Attachment A
Montgomery Planning Staff Comments on MCPS Capital Projects

Comments for New Projects in the Board of Education’s Request

Burning Tree ES, Major Capital Project (2031):

Figure 1. MCPS Site Plan Approach 4C (A) - Courtyard Scheme

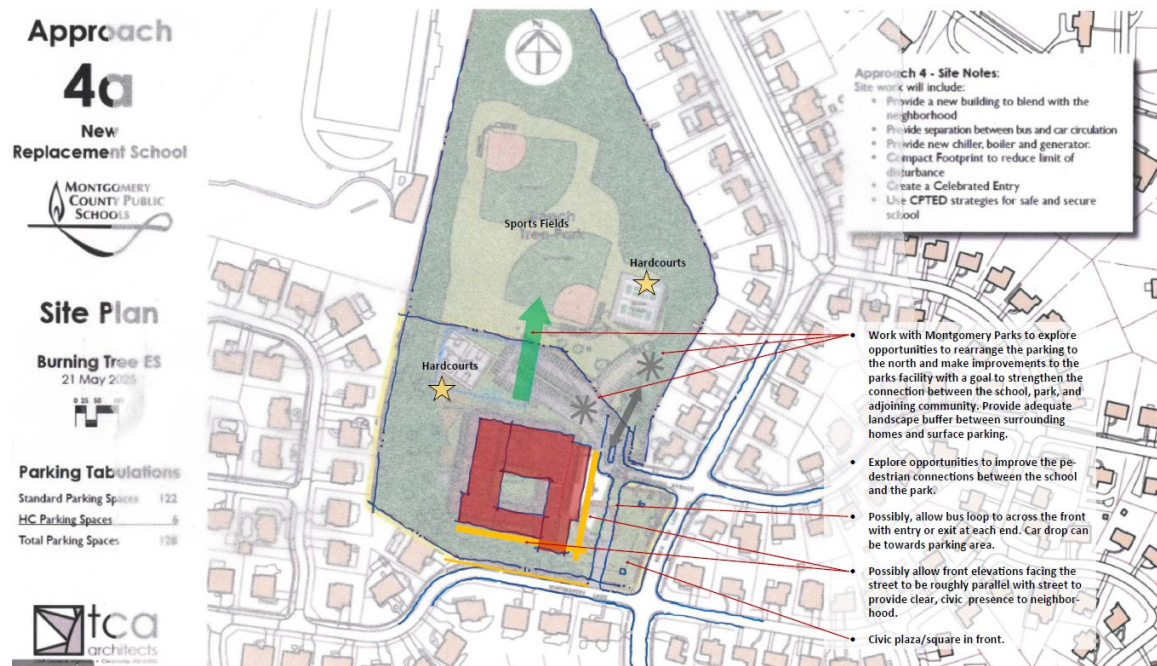
Comments are based on site plan options presented by MCPS in May 2025 labeled ‘4C(A) – Courtyard Scheme’ and ‘4C(B) – Open Court Scheme’ (see Figure 1 and Figure 2)

- Possibly allow front elevations facing the street to be roughly parallel with the streets to provide a clear, civic presence to the neighborhood.
- Possibly create a civic plaza/square in front.

- Improve pedestrian access to the park from the school and neighborhood.
 - The school uses the fields a lot so the design should accommodate children moving between the school and the park.

- Fields are permitted for public use, which should be a consideration in the design.
- Explore opportunities to rearrange the parking area by aligning it more to the east. The goal is to strengthen the connection between the school, the park, and the adjoining community.

- Any improvements to the parking area on parkland should maintain the general location and number of parking spaces, and serve as parking for public park users.

- The parking lot on parkland should not be utilized to improve the flow of school traffic during pick-up/drop-off.
- Provide adequate landscape buffers between surrounding homes and surface parking.

- If proceeding with 'Approach 4C(A) – Courtyard Scheme', possibly allow bus loop to cross the front with entry or exit at each end. Car drop off can be towards the parking area.

- Consider including a gym with a larger, full-sized basketball court that can accommodate multiple classes and can be made available to the greater community after school hours.

- Stormwater management should be limited to MCPS property.
- Any concepts that are advanced that include new amenities or impacts on parkland will need to go through Parks' Concept Review before they would be approved at Mandatory Referral. Ultimately, any work approved on parkland would require a Park Construction Permit prior to construction.

Figure 2. MCPS Site Plan Approach 4C (B) – Open Court Scheme

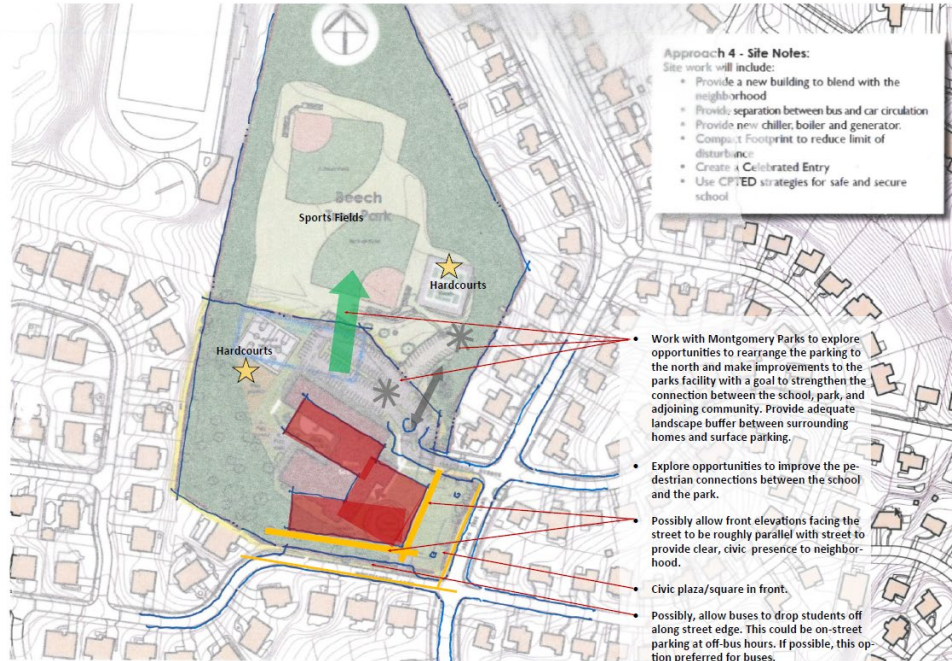
- If proceeding with 'Approach 4C(B) – Open Court Scheme', possibly allow buses to drop students off along the street edge. This could be neighborhood on-street parking at off-bus drop-off hours. If possible, this option is preferred for buses to minimize impervious surfaces on site and to maximize the existing infrastructure of the streets.
